Access Compliance Report

Public Rights-of-Way

| Intersection ID: 5200 | Main Street: MT_HOLLY-HUNTERSVILLE_RD | Cross Street: NORTHWOODS_FOREST_DR | Location: SE |
| ADA ID: D03C7133DFB6 | Ramp Type: Perp | Initial Pass/Fail: Fail | Overall Compliance: No |

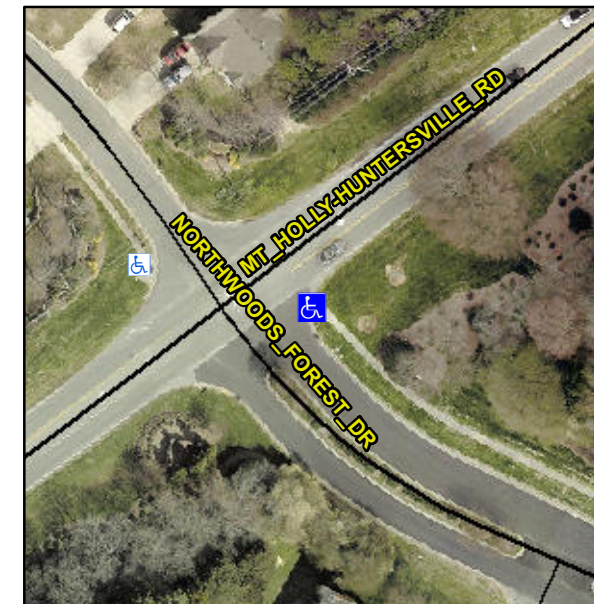
Not Found, R304.5.1, R304.2.2

| Compliance | Description | Data | Compliance | Description | Data |
|------------|-----------------------|------|------------|-----------------------------|------|
| N/A | Ramp Length (in) | 70.0 | No | Ramp Slope (%) | 9.5 |
| No | Ramp Width (in) | 43.0 | Yes | Ramp XSlope (%) | 4.0 |

Remove & Replace Entire Ramp.
